DEPARTMENT OF TRANSPORTATION**National Highway Traffic Safety Administration****49 CFR Part 571**

Federal Motor Vehicle Safety Standards; Child Restraint Anchorage Systems

ACTION: Final rule, response to petitions for reconsideration; corrections.

Figure 22. Placement of Symbol on the Seat Back
and Seat Cushion of a vehicle

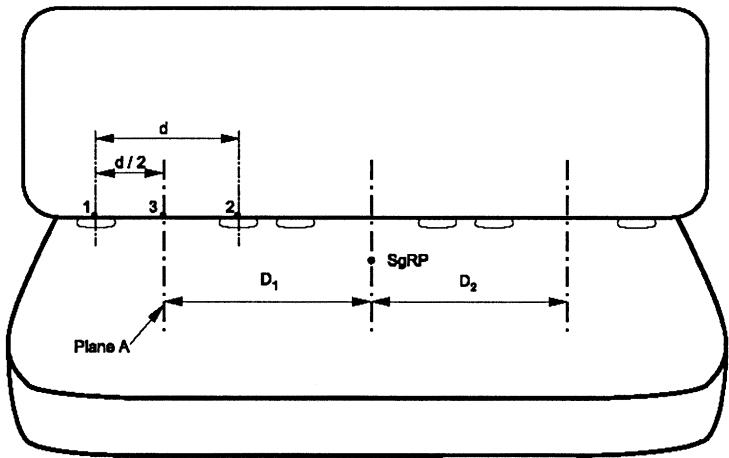
Ford Motor Company petitioned for reconsideration of this decision, stating that the 75 mm upper limit causes problems for vehicles that have large

Ford stated that increasing the permitted vertical range to 50 to 100 mm would allow longer vertical access slits.

NHTSA's Response: Ford has submitted new information on the need for a longer vertical slit that has convinced NHTSA that the permitted vertical range of the circle should be increased to 100 mm from the LATCH bar. An increase to 100 mm balances the need for a longer slit (to decrease the wear-and-tear on the fabric, leather or other material out of which the seat cover is fabricated) with the need for reasonable proximity of the circle to the anchorage bar. This final rule amends S9.5(a)(3) and Figure 22 to permit the circle to be 50 to 100 mm above the bar.

(3) That is located such that its center is on each seat back between 50 and 100 mm above or on the seat cushion 100 ± 25 mm forward of the intersection of the vertical transverse and horizontal longitudinal planes intersecting at the horizontal centerline of each lower anchorage, as illustrated in Figure 22. The center of the circle must be in the vertical longitudinal plane that passes through the center of the bar (± 25 mm).

Figure 20 – Measurement of Distance Between Adjacent Seating Positions for Use in Simultaneous Testing

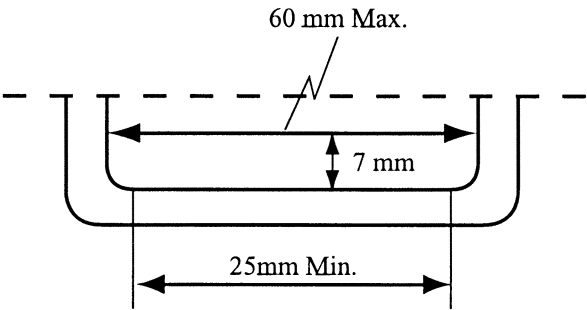
The agency implemented the amendment applying to the simultaneous testing of tether anchorages by amending S6.3.3 and S6.3.4 and adding a Figure 20. In S6.3.3, S6.3.4 and Figure 20, reference is made to measuring a distance between "the two lower anchorages" at the seating position. The Alliance noted that the reference does not provide for determining whether to test simultaneously tether anchorages at seating positions that do not have "lower anchorages" (child restraints would be attached at such seating positions by use of the vehicle's belt system and top tether anchorage). The

Alliance suggested that NHTSA correct S6.3.3, S6.3.4 and Figure 20 by specifying that the midpoint of such seating positions "lies in the vertical longitudinal plane that passes through the SgRP [seating reference point] of the seating position." NHTSA agrees and has made the correction in this document.

(1) The midpoint of the seating position lies in the vertical longitudinal plane that is equidistant from vertical longitudinal planes through the geometric center of each of the two lower anchorages at the seating position. For those seating positions that do not provide lower anchorages, the midpoint of the seating position lies in the vertical longitudinal plane that passes through the SgRP of the seating position.

(1) The midpoint of the seating position lies in the vertical longitudinal plane that is equidistant from vertical longitudinal planes through the geometric center of each of the two lower anchorages at the seating position. For those seating positions that do not provide lower anchorages, the midpoint of the seating position lies in the vertical longitudinal plane that passes through the SgRP of the seating position.

Figure 21. Length of Lower Anchorage Bars

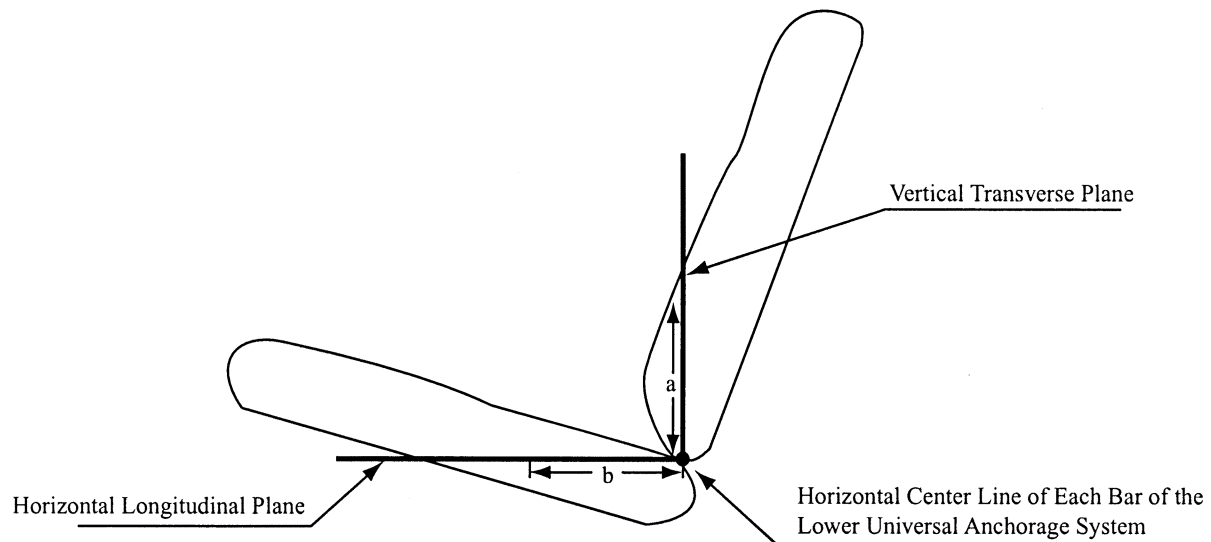
The Alliance and Johnson Controls petitioned for reconsideration of the change made by the June 2003 final rule. The petitioners stated that Figure 21 is incorrect because, they believed, measuring the inside portion of the bar would include the inside radii of the lower anchorage bars in the measurement of bar length. Because curved portions of the bar could be included in what was supposed to be a measurement of the "straight" portion of the bar (the straight portion of the bar to which the child restraint hardware connects), petitioners said that the effect of Figure 21 could limit the straight portion of the bar to less than 50 mm. The Alliance stated that some anchorages that had met S9.1.1(c) with a maximum length of 40 mm may now fail the 50 mm limit when measured according to Figure 21.

In a March 24, 2004 supplement to its petition for reconsideration, the Alliance expressed further concern about Figure 21 because, petitioner stated, it does not show how to measure the length of anchorages that do not have straight and parallel sides. (The bar depicted in the figure had straight and parallel sides.) At the same time, the petitioner recognized that the agency believed that measuring the inside opening of the bar at specified points on the bar improved the objectivity of the test. To address the agency's concern and the alleged problems with Figure 21, the petitioner suggested that S9.1.1(d) be amended to specify: (1) That the bar is measured in a vertical plane 13 mm rearward of the vertical plane that is tangent to the forward face of the anchor bar; and (2) that the bar must not be more than 60 mm in length between the anchor bar supports or other structural members that restrict lateral movement of a child restraint attachment. The petitioner believed that the 13 mm provides enough clearance to enable child restraints to attach to the bar.

NHTSA's Response: The agency has decided that Figure 21 is useful in showing where the LATCH bar is to be measured and should generally be retained. Yet, the agency also agrees that revisions to the figure and to the corresponding regulatory text (S9.1.1(c)) are needed, as discussed by the petitioners. As explained below, this final rule makes the amendments to the figure and regulatory text suggested by the Alliance, with one difference.

allowable bar length to 50 mm, this final rule increases the maximum allowable bar length to 60 mm. Increasing the maximum bar length to 60 mm, measured as shown in Figure 21 (as revised today), will allow for the straight portion of the bar to be increased to 50 mm. This final rule also clarifies that the bar must not be more than 60 mm in length between the anchor bar supports or other structural members of the vehicle that restrict lateral movement of the components of a child restraint that are designed to attach to the bars. In other words, the LATCH anchorage bars are not required to have the "U" shape shown in Figure 21. (The Figure will also bear wording that the depiction of the U shape is for illustration purposes only.)

Another amendment relates to the Alliance's suggestion that S9.1.1(d) be amended to specify that the bar is measured in a vertical plane 13 mm rearward of the vertical plane that is tangent to the forward face of the anchor bar. The agency agrees that defining with more specificity where the bar is measured improves the objectivity of the requirement. However, NHTSA believes that the bar should be measured with reference to the vertical plane that is tangent to the rearward face of the anchor bar (rather than the vertical plane that is tangent to the forward face of the bar), taking into account the 6 mm thickness of the bar. Thus, the bar would be measured in a vertical plane that is 7 mm rearward of the vertical plane that is tangent to the rearward face of the anchor bar.

- (i) Not less than 25 mm in length, and
- (ii) Are not more than 60 mm in length between the anchor bar supports or other structural members of the vehicle that restrict lateral movement of the components of a child restraint that are designed to attach to the bars, measured in a vertical plane 7 mm rearward of the vertical plane that is tangent of the rearward face of the anchor bar.
